**POST BID ADDENDUM NO. 03
LEGRANDE ELEMENTARY SCHOOL ADDITION AND RENOVATION
SCB PROJECT NO. 2210**

FROM: Sherman Carter Barnhart Architects
144 Turner Commons Drive, Suite 110
Lexington, Kentucky 40508

DATE: September 11, 2023

This Addendum consists of 50 pages / drawings.

2 FLOOR PATTERN PLAN ADD #3
3/32" = 1'-0"

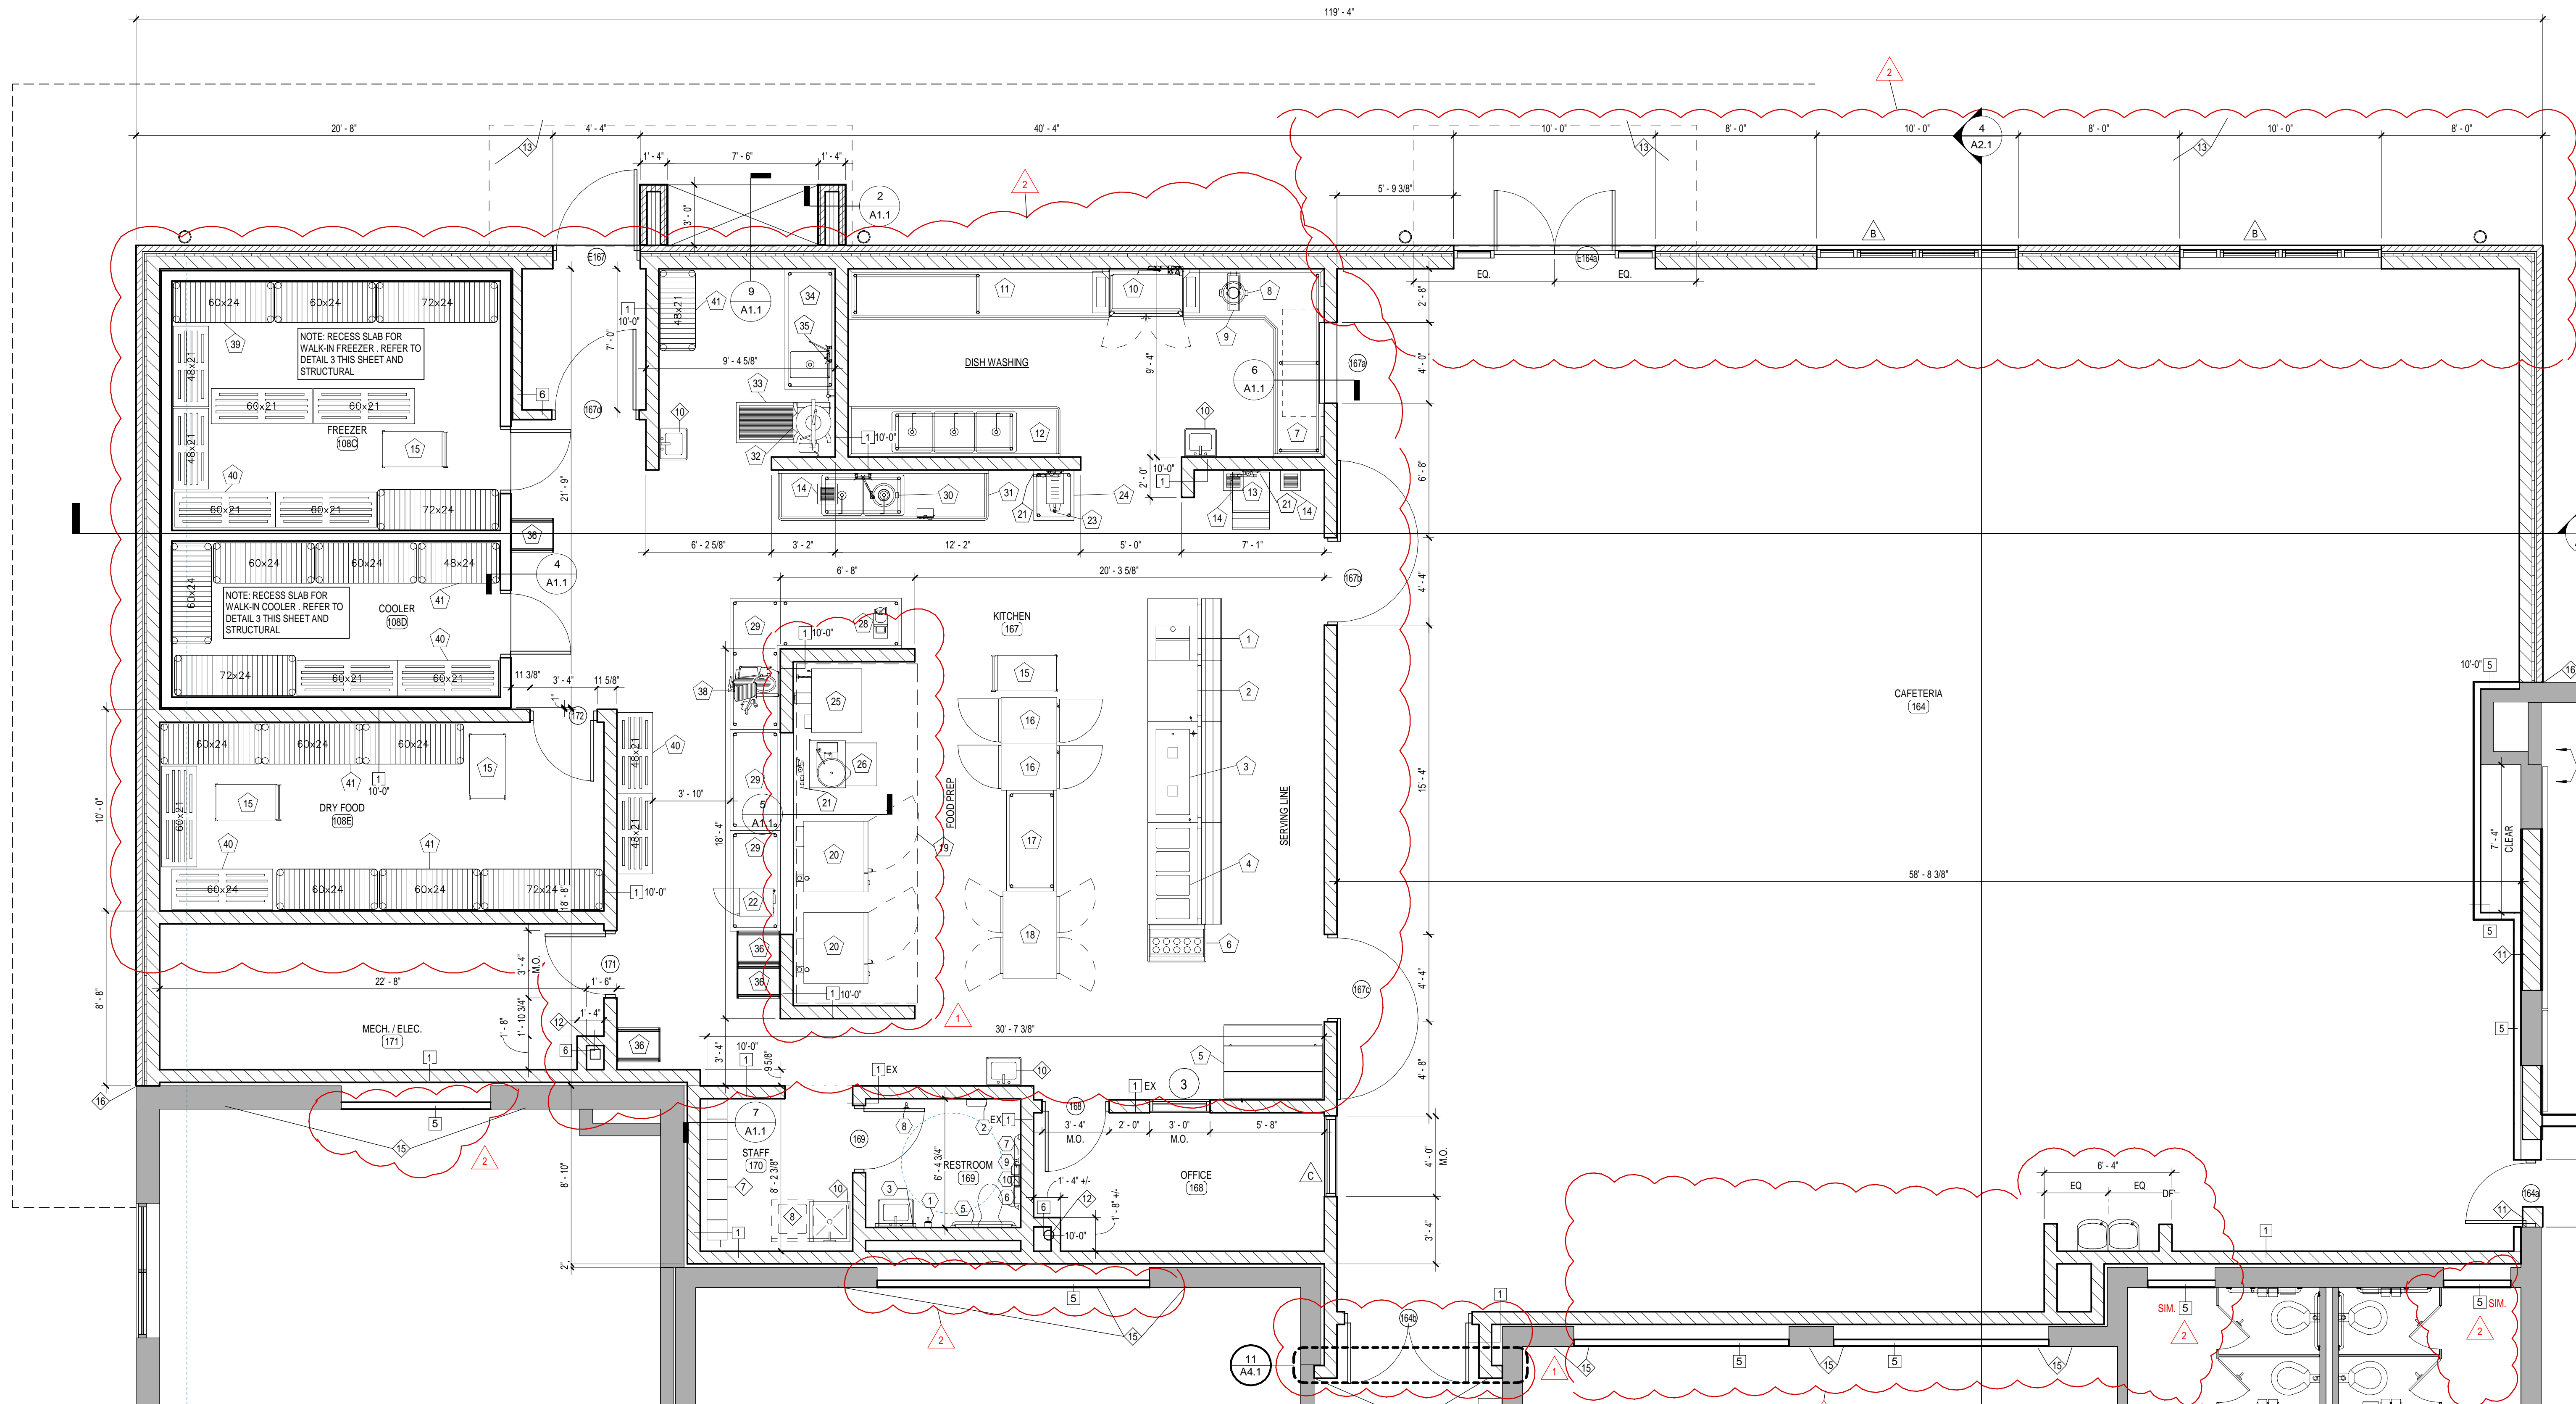
3. **Revise** flooring in cafeteria to be VCT (not terrazzo) and base to be vinyl (not terrazzo). See attached drawings.
Deduct: \$_____.
4. **Omit** male / female / staff toilets and 2-associated chases . Relocate / reduce length of leader piping and relocate drinking fountains. See attached drawings.
Deduct: \$_____.

1 FIRST FLOOR PLAN - FIRE PROTECTION
SCALE: 1/8" = 1'-0"

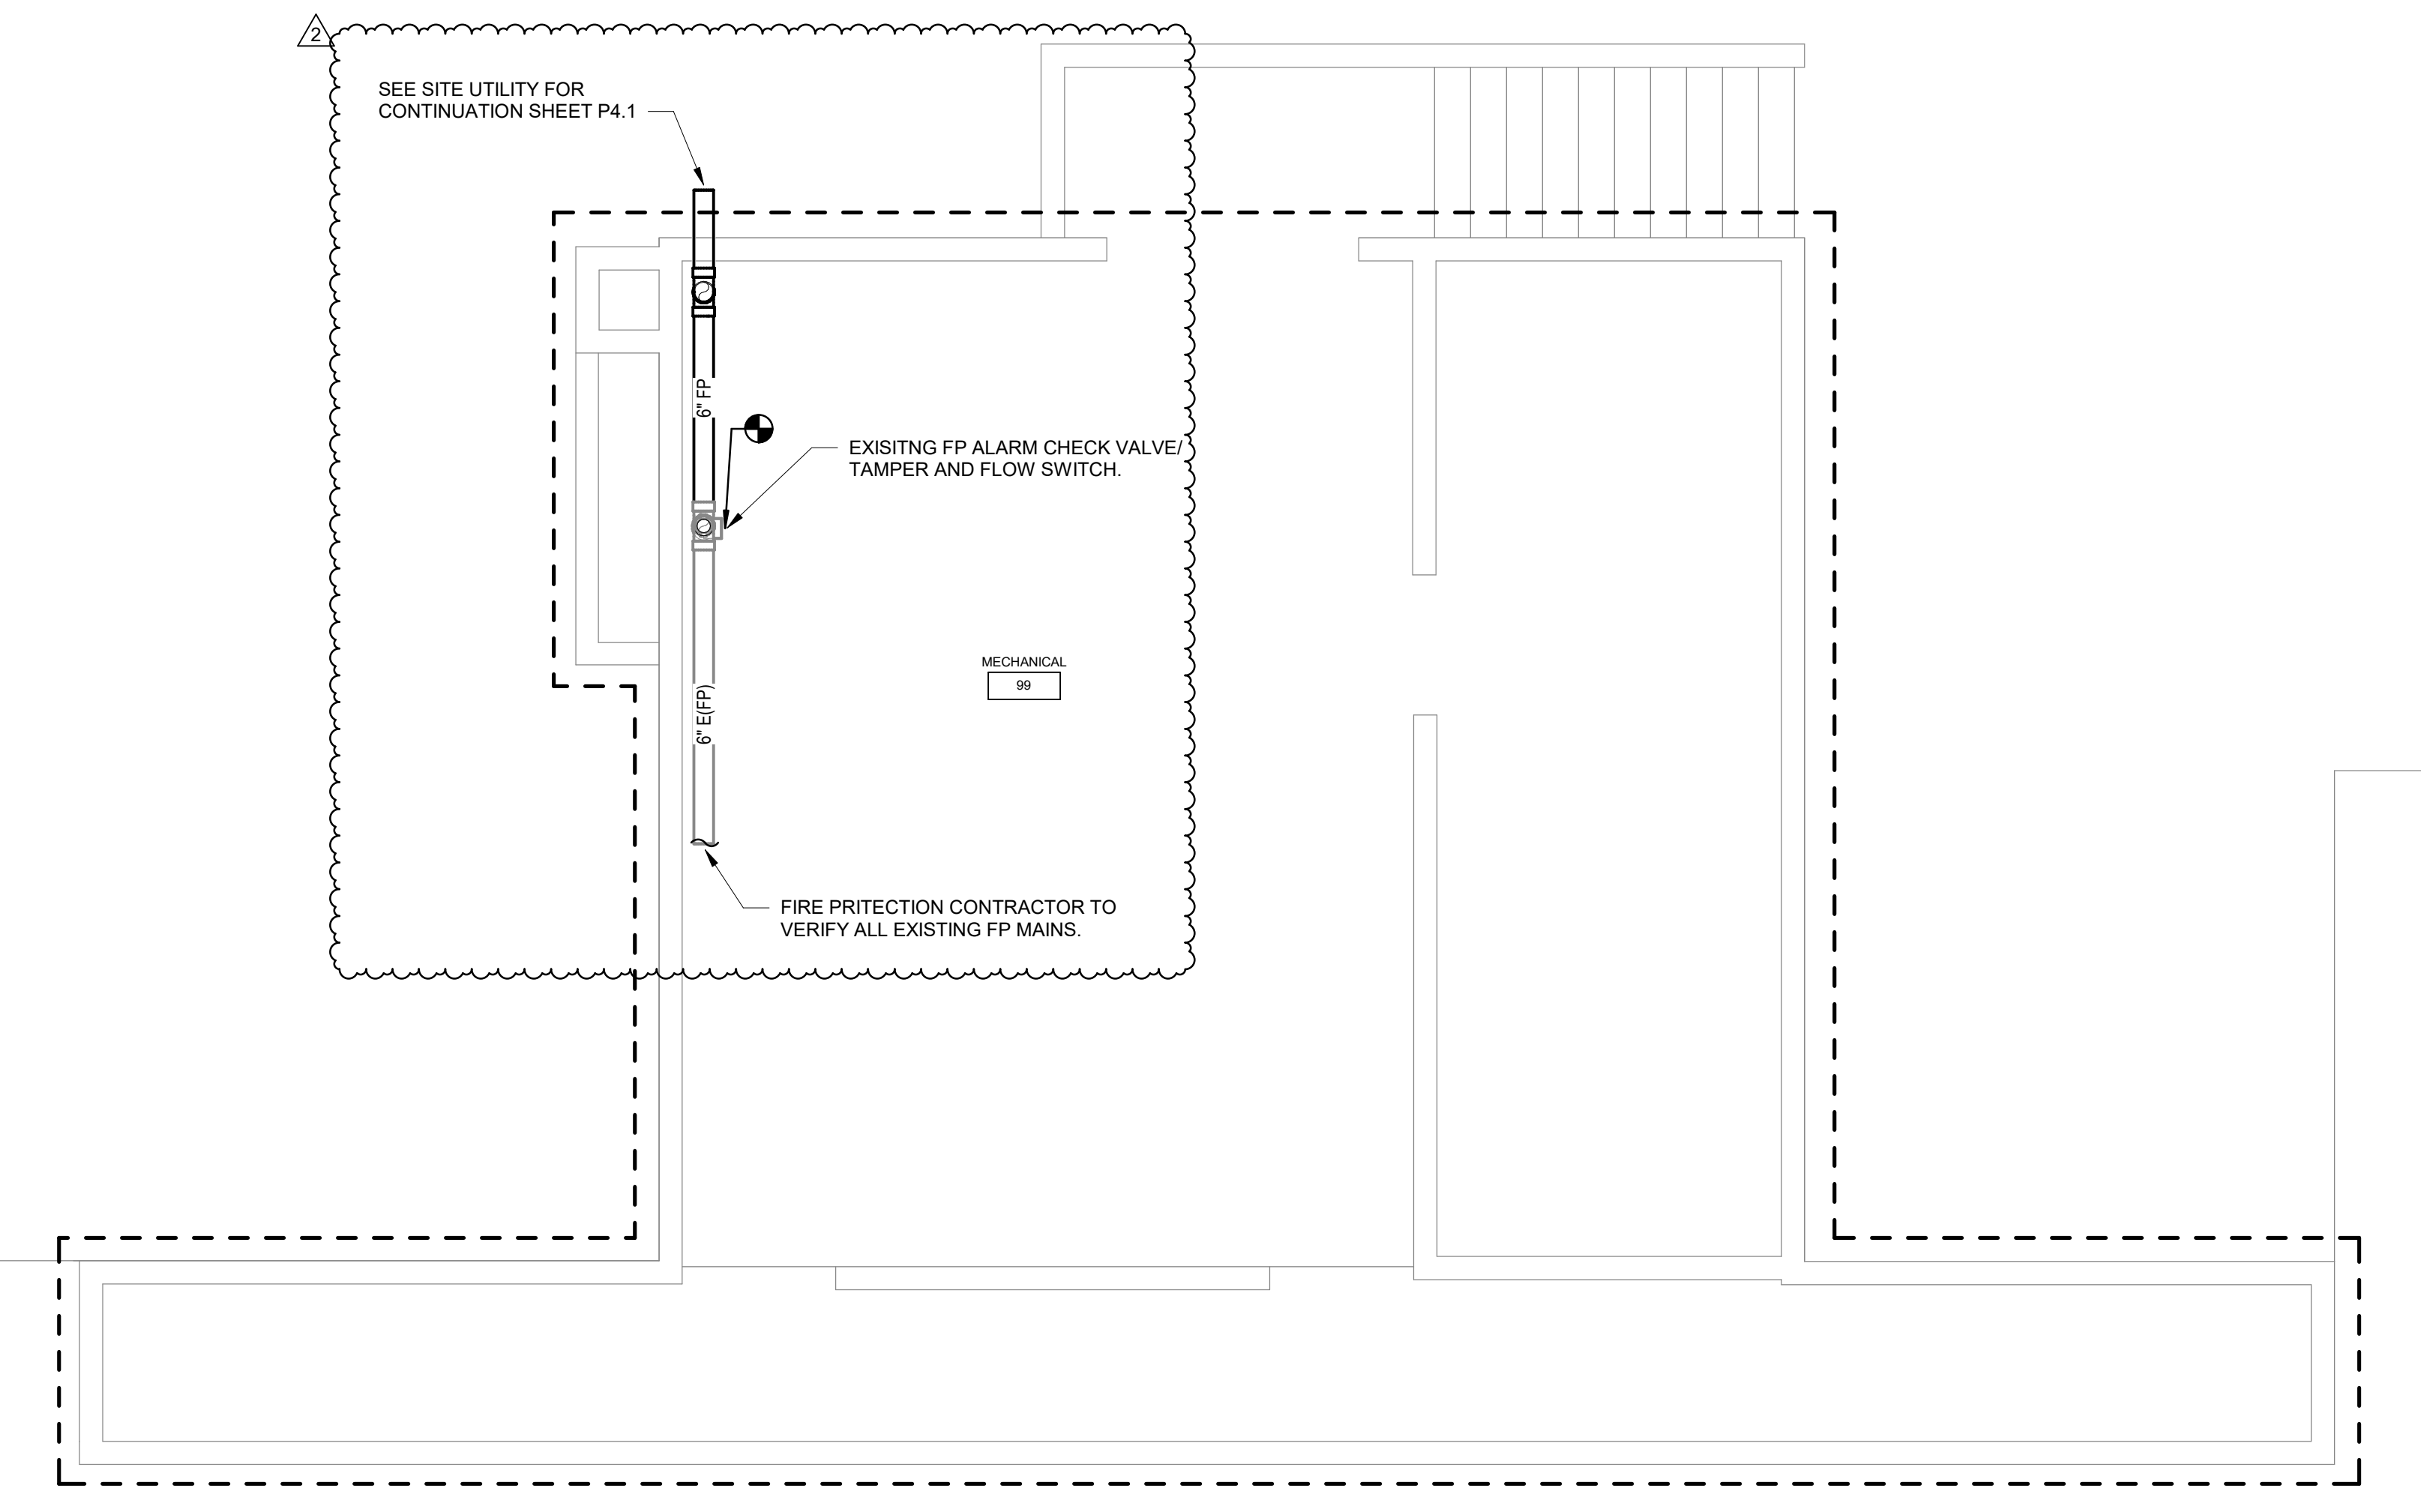
1. Sheet FP-1.1 - FIRST FLOOR PLAN -FIRE PROTECTION
 - a. Removed Fire Protection re-work of the admin Area.
Add or Deduct: \$_____.
 - b. Clarified fire protection entrance and connection point to existing fire riser.
Add or Deduct: \$_____.

1 BELOW SLAB PLAN - PLUMBING DEMOLITION
SCALE: 1/8" = 1'-0"

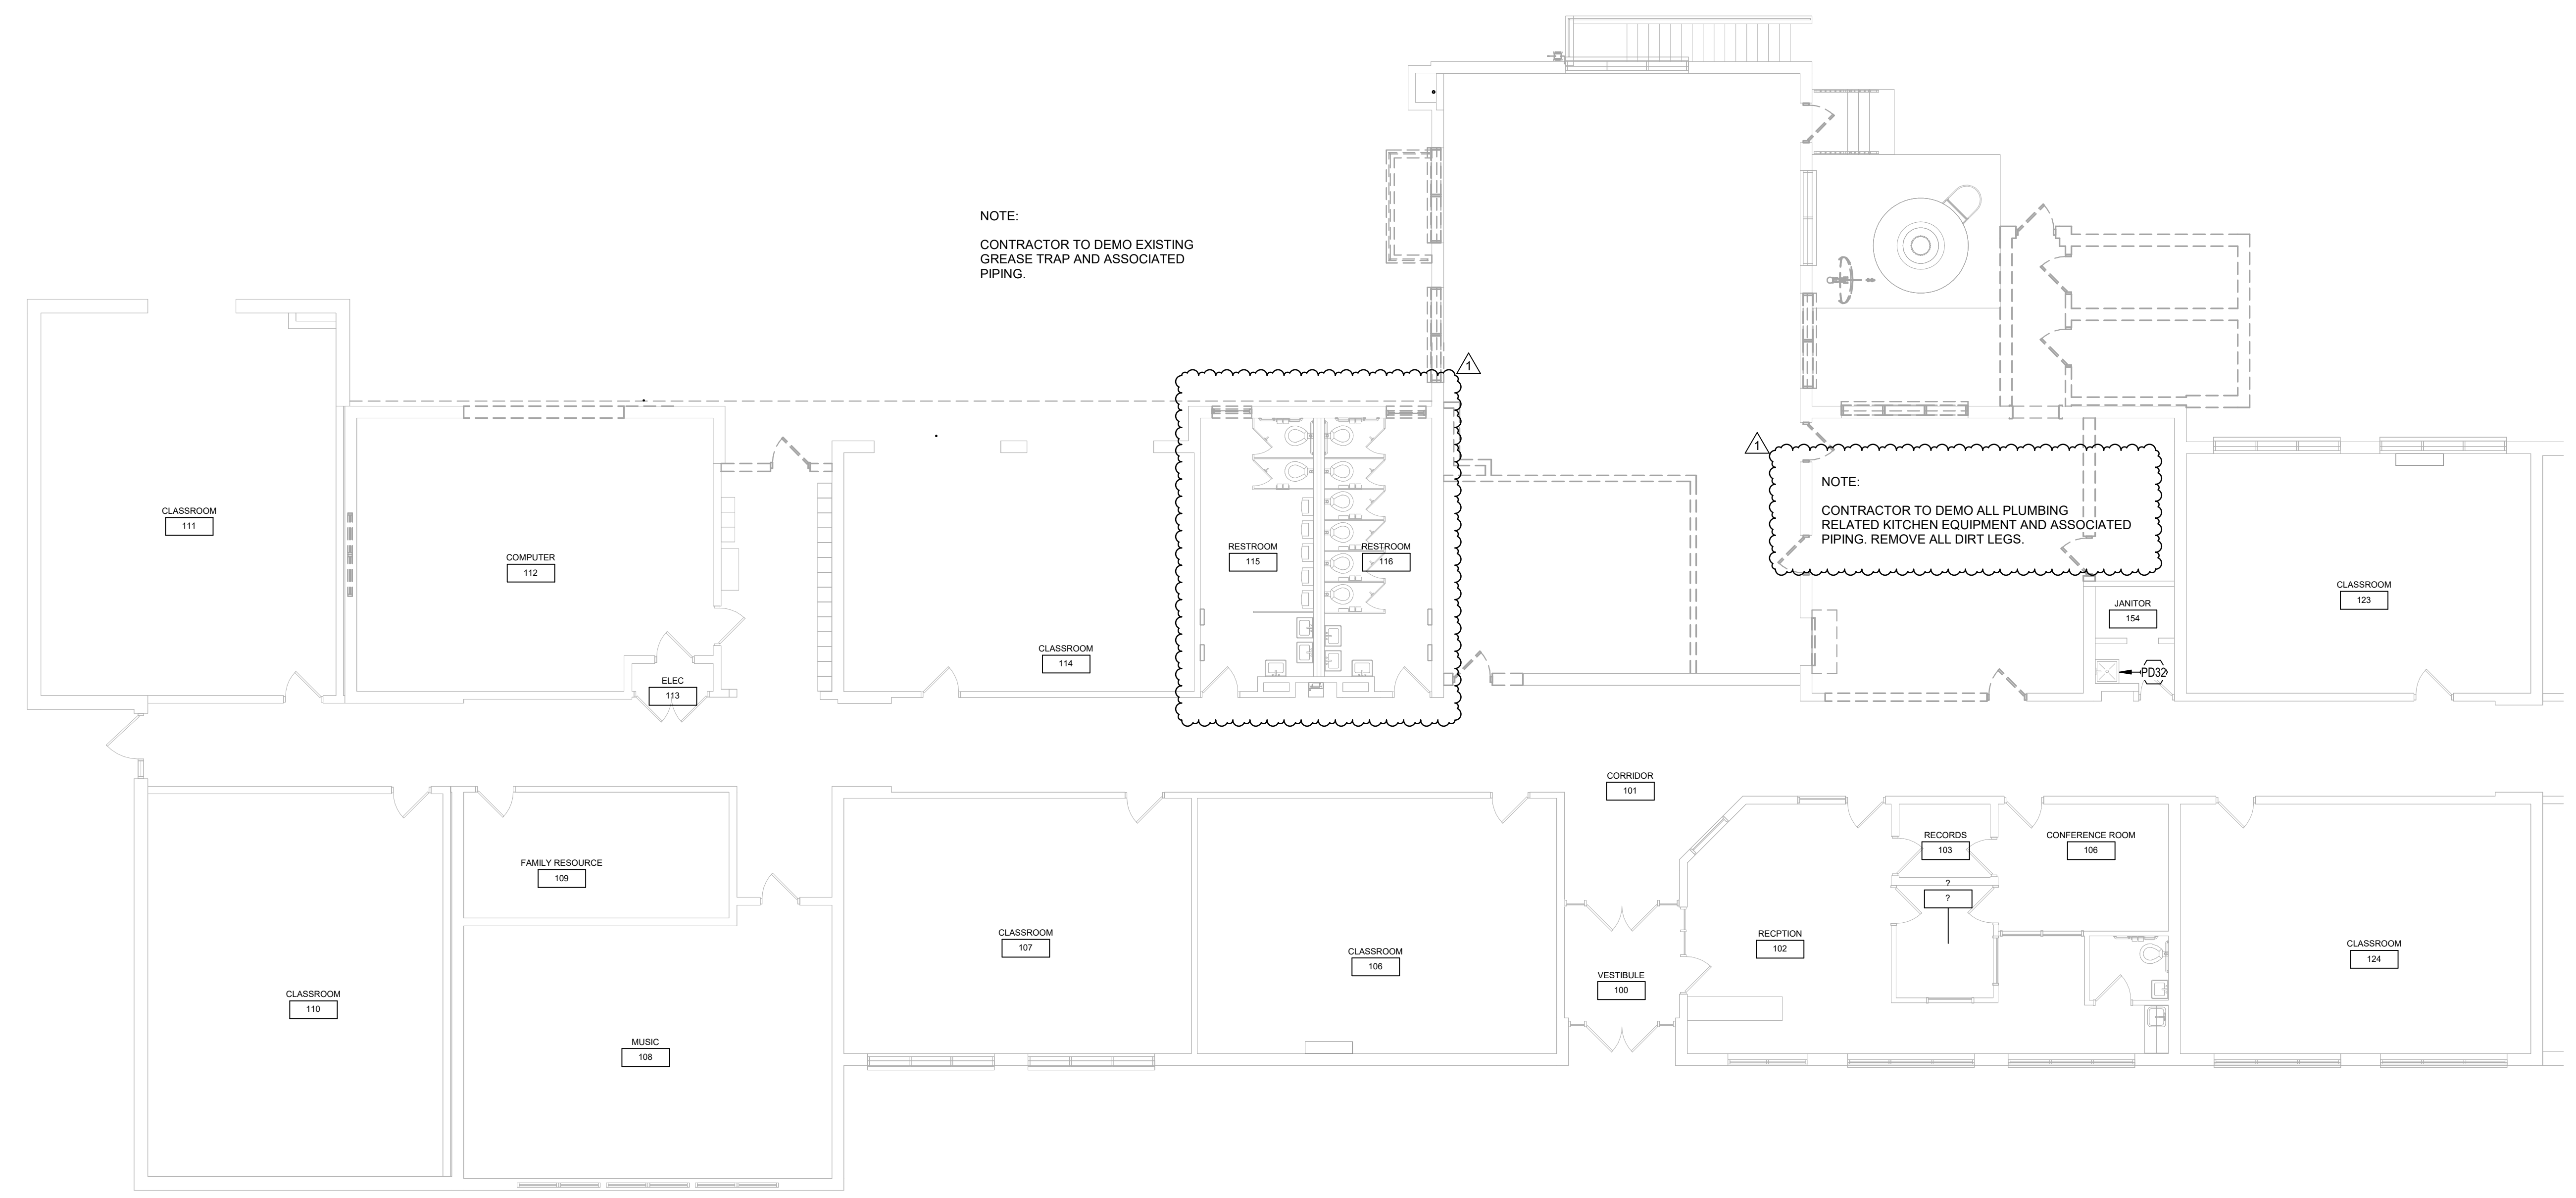
- a. Omitted restroom 115/116 plumbing demolition.
Add or Deduct: \$_____.
3. Sheet P1.2 – FIRST FLOOR PLAN - PLUMBING DEMOLITION
 - a. Omitted restroom 115/116 plumbing demolition.
Add or Deduct: \$_____.
